# 1ST & PIKE

103 PIKE STREET

EARLY DESIGN GUIDANCE 2  
06 FEBRUARY 2018  
DPD #3028428

1. ARCHITECTURAL CONTEXT - EXPANDED SITE PLANS

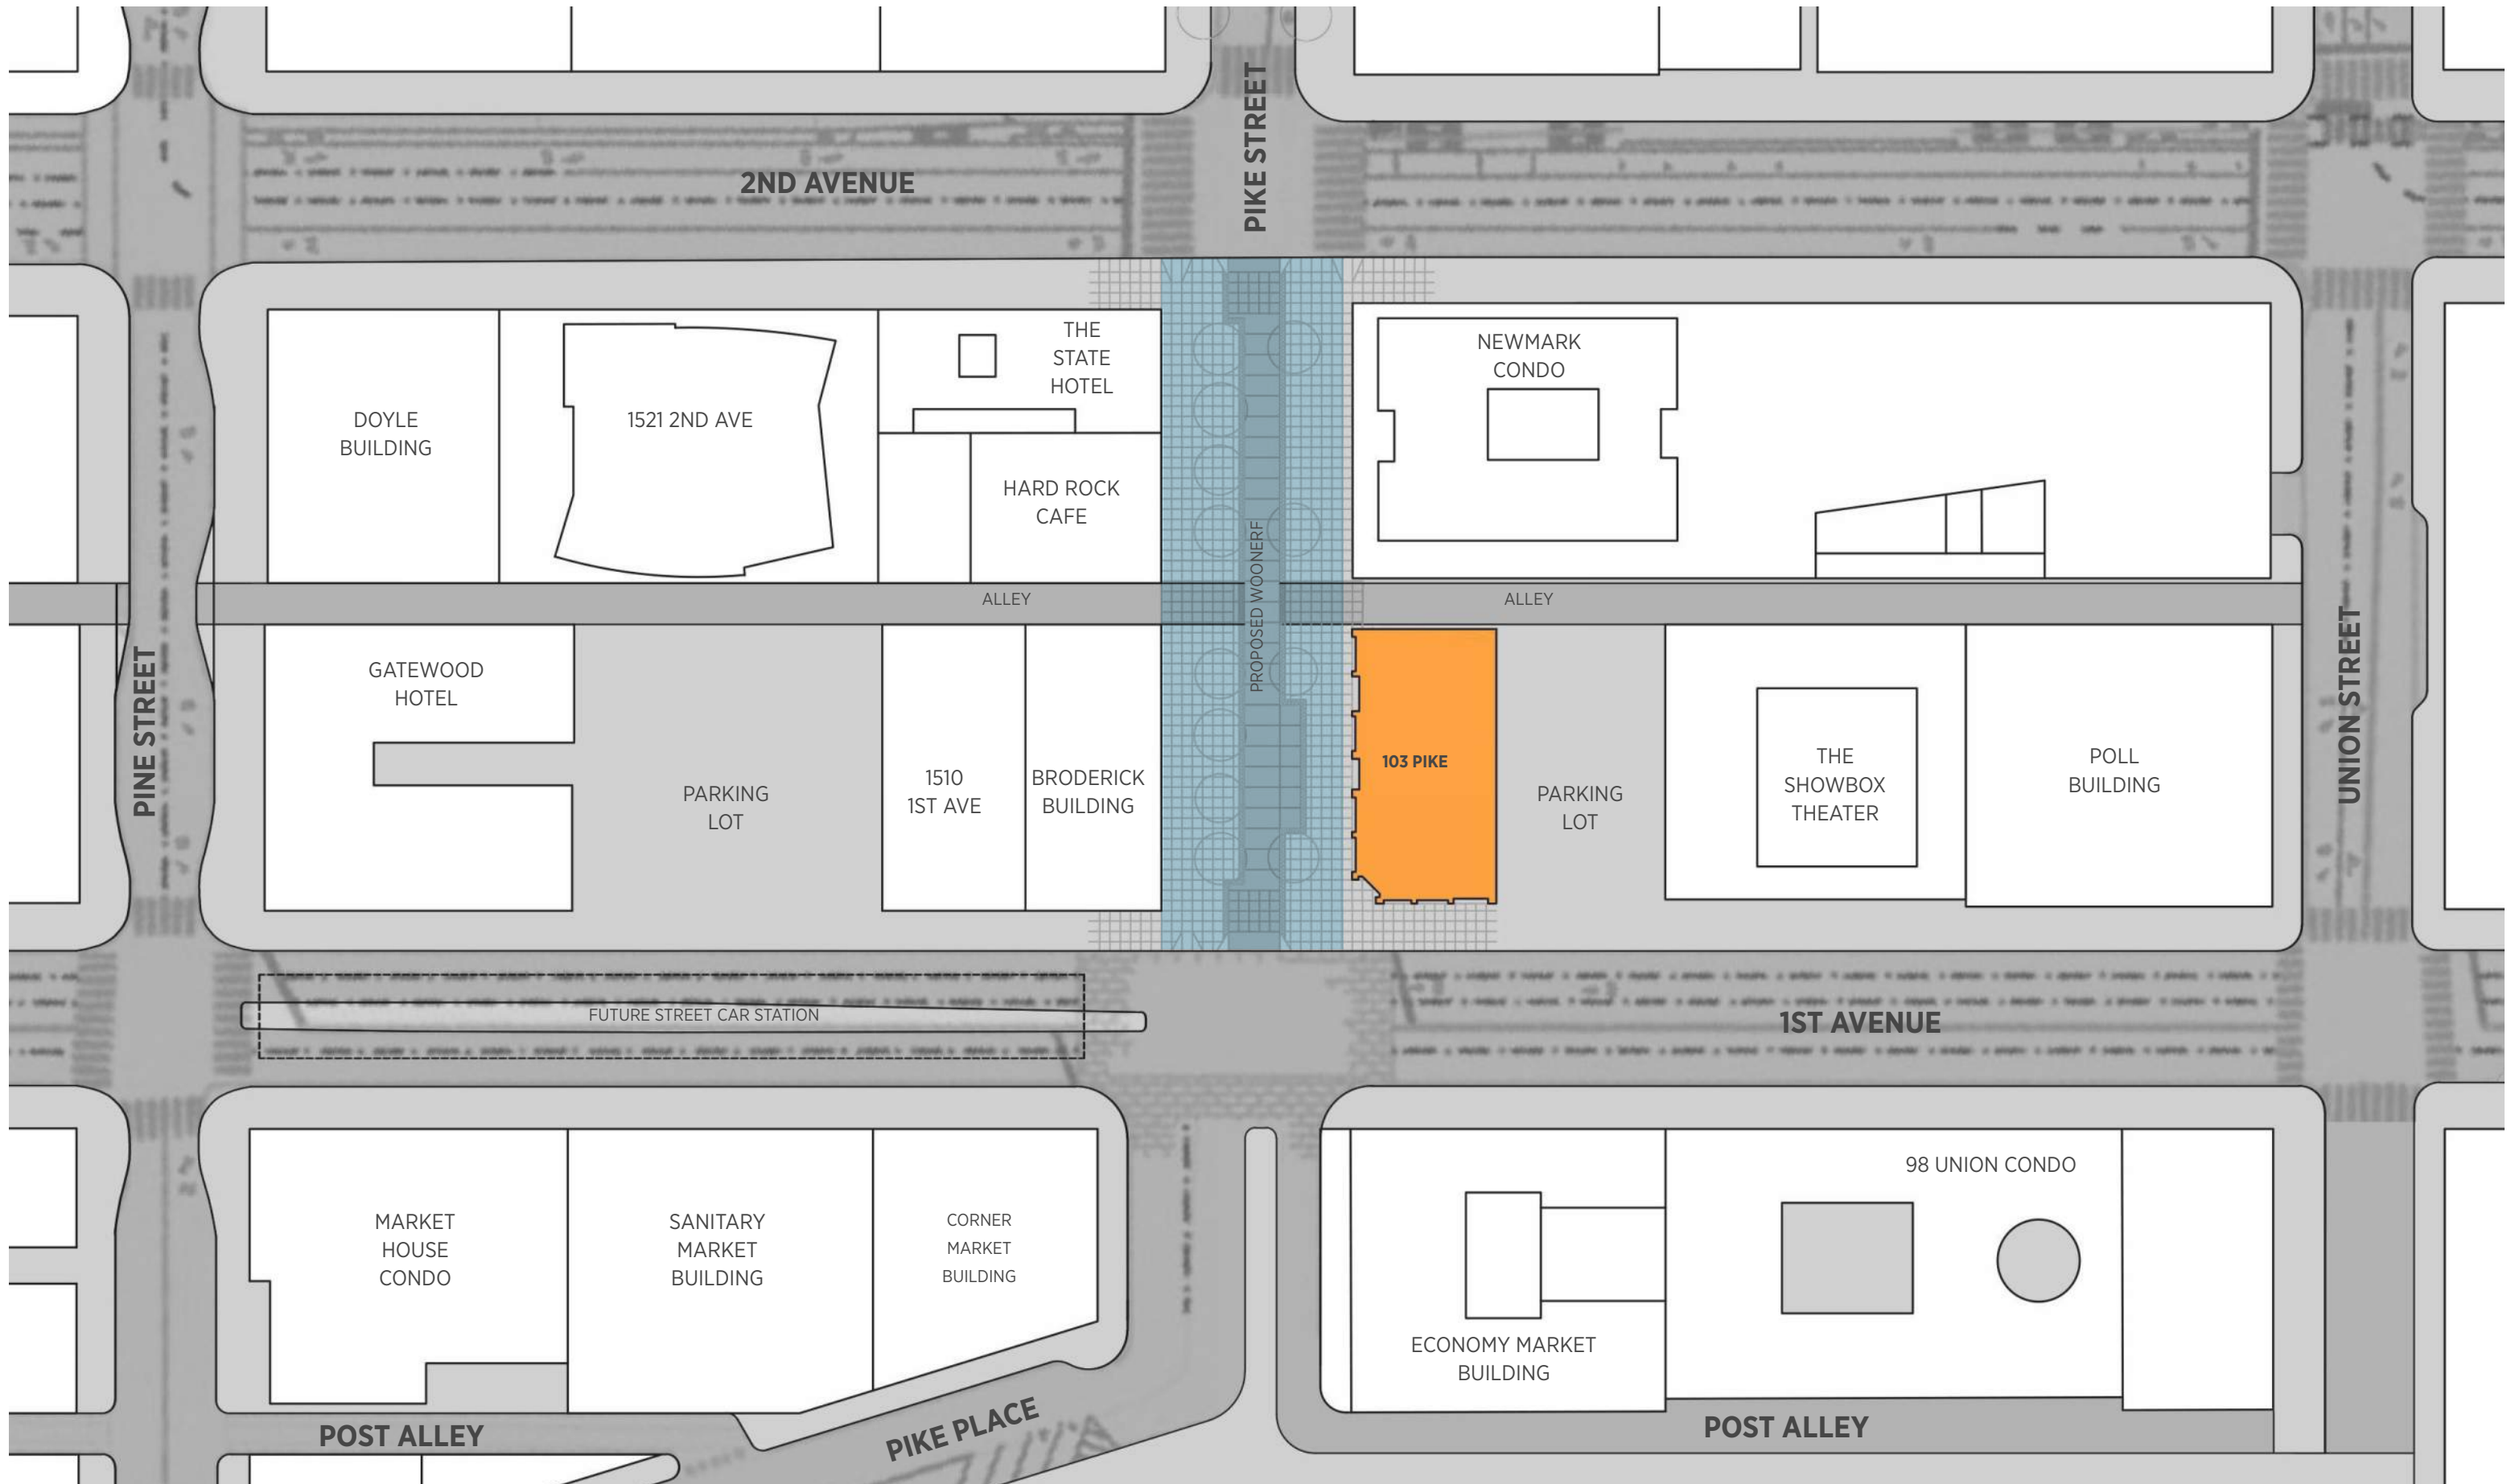
1.a.i The Board agreed with the applicant and the public that the subject property is a recognized site that serves as the gateway to the main entrance of an iconic property—Pike Place Market. The Board explained that understanding the context along 1st Avenue and Pike Street is critical to ensuring future massing will positively respond to the physical environment. The Board was disappointed with the initial amount of context provided and requested that a more comprehensive neighborhood context analysis be provided in the design packet and presented at the next EDG meeting.

We have provided an expanded site plan, showing future and proposed street improvements. There is a proposed streetcar stop on First Avenue between Pine and Pike Street. Pike Street between 1st and Second Avenue is intended to become a pedestrian dominated woonerf and is part of the Pike/Pine Renaissance Project. [www.waterfrontseattle.org/pike-pine](http://www.waterfrontseattle.org/pike-pine)

# 1. ARCHITECTURAL CONTEXT - LANDMARK STRUCTURES

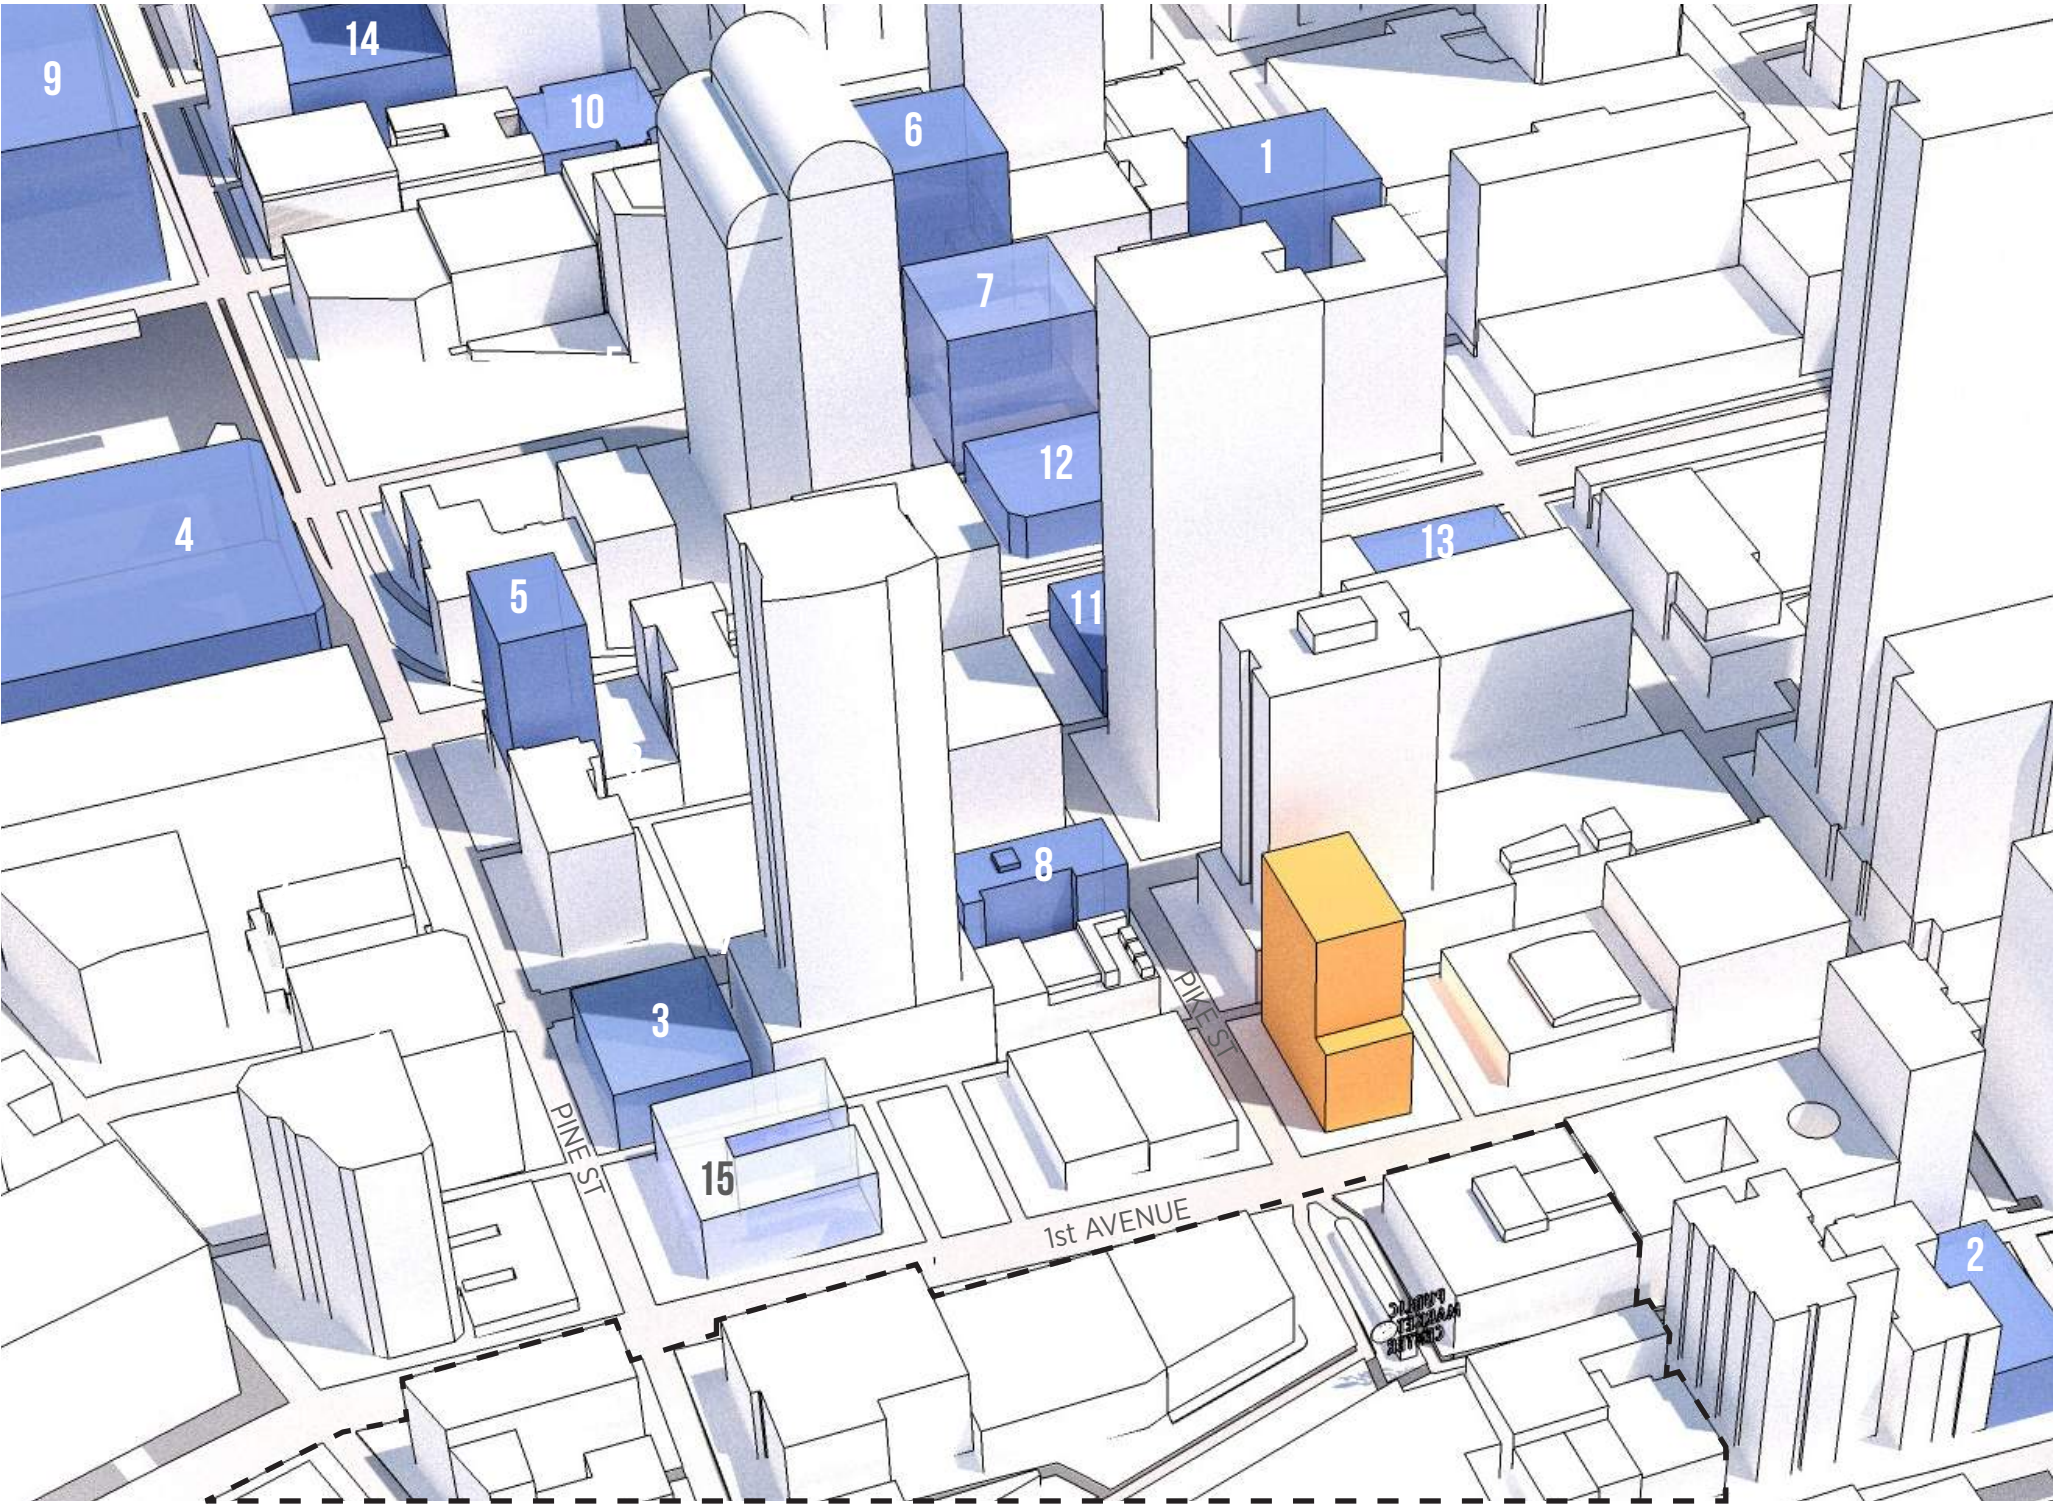
1.a.i Identify existing and potential City Landmarks.

The map on this page shows the location of landmark and potential landmark structures near our site. 103 Pike Street has been twice nominated for landmark designation and failed to receive it both times.

1. ARCHITECTURAL CONTEXT - FIRST AND PIKE INTERSECTION

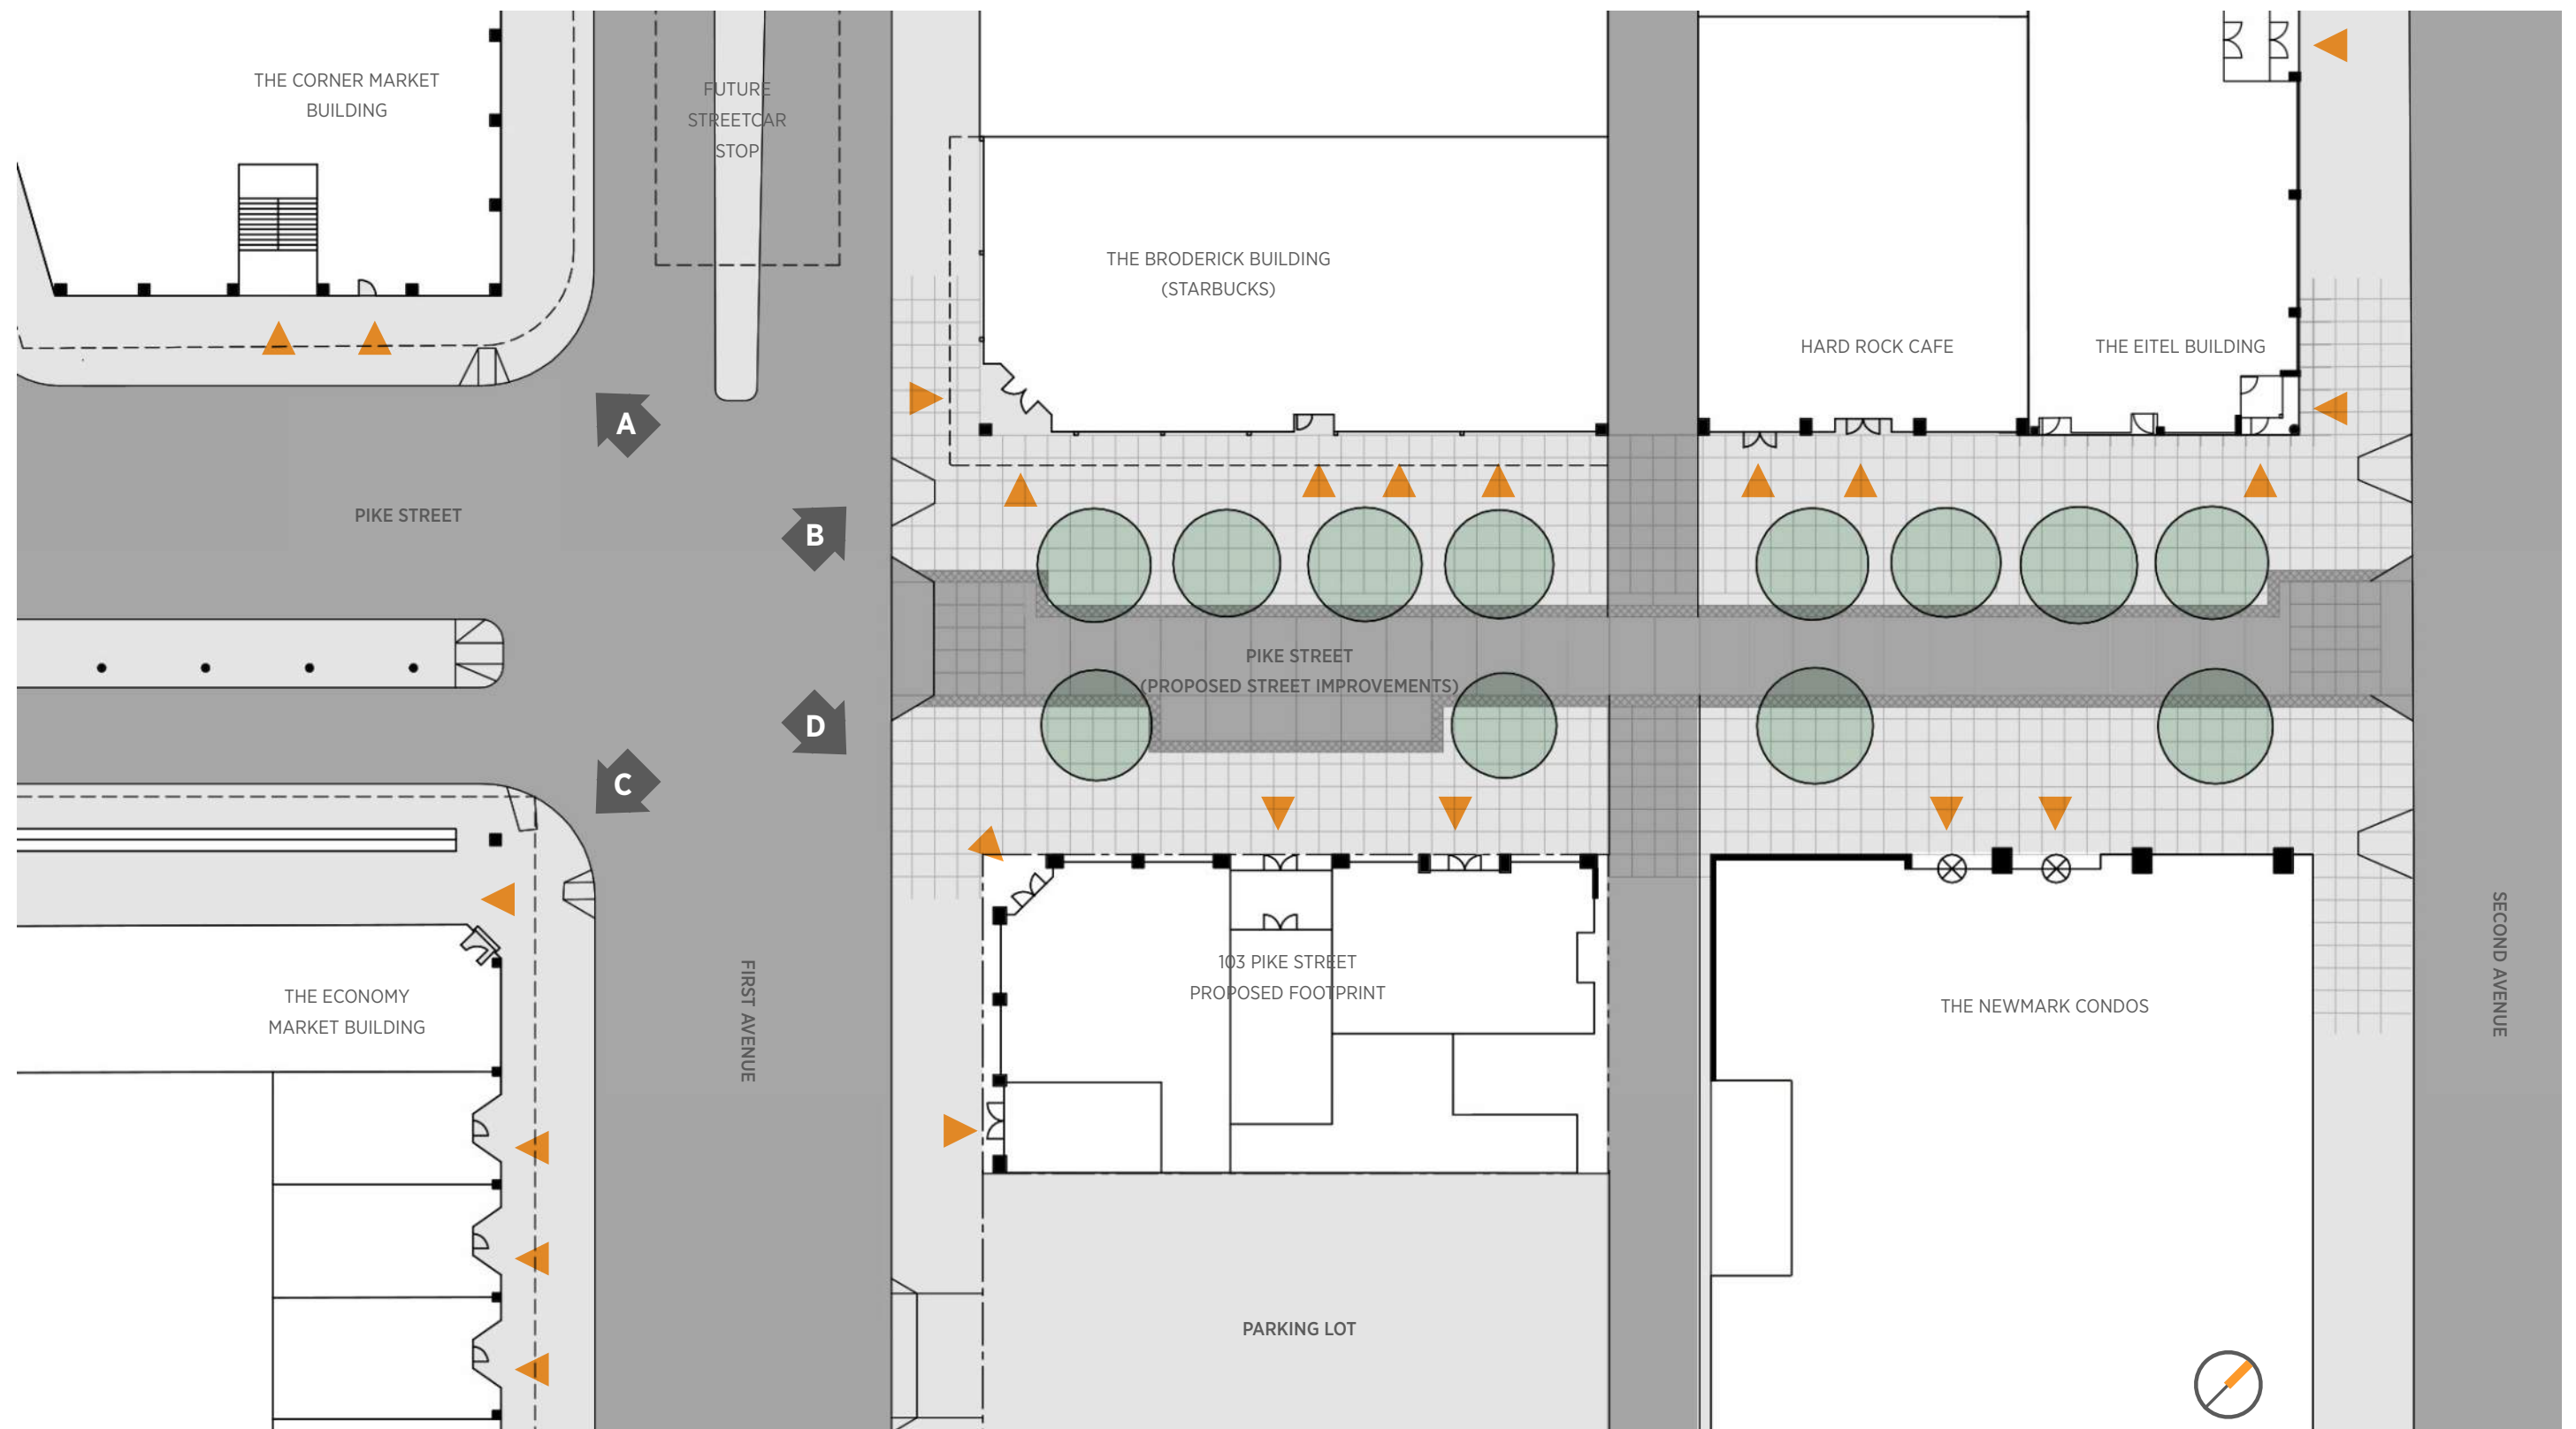
1.a.i Identify existing building Entries, Street Patterns, and the four corners of 1st Avenue and Pike Street.

Building corners and entries have been documented with photos, plans, and elevations. Common traditional features, such as bay column spacing, corner entries, and inset side entries, have been incorporated into the project design to reflect the patterns found throughout the neighborhood.
